Access Compliance Report Public Rights-of-Way (Curb Ramps)

Main Street: RUSHMORE_LN Cross Street: BRYCE_PL Location: W

ADA ID: RPAT211007144150 Ramp Type: Type 1 - Perpendicular Diagonal Initial Pass/Fail: Pass Overall Compliance: No Severity Score: 20

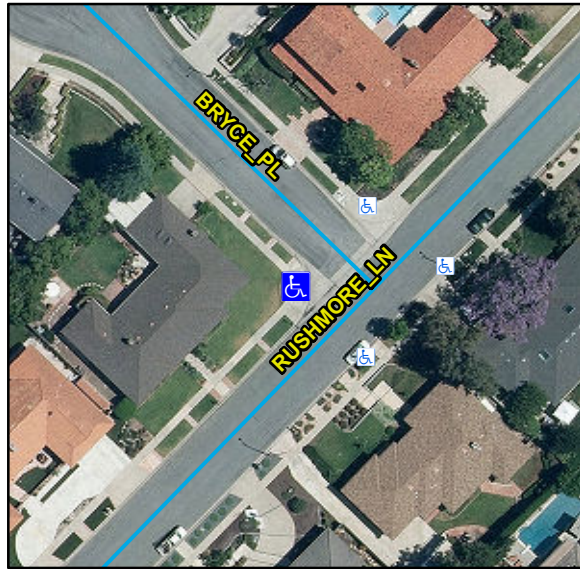
R204.3, R304.2.1, R304.2.2-Perp, R304.3.2-Para, R304.5.3, R305, STD 1115

Remove & Replace Curb Ramp With Two New Directional Ramps or Equivalent.
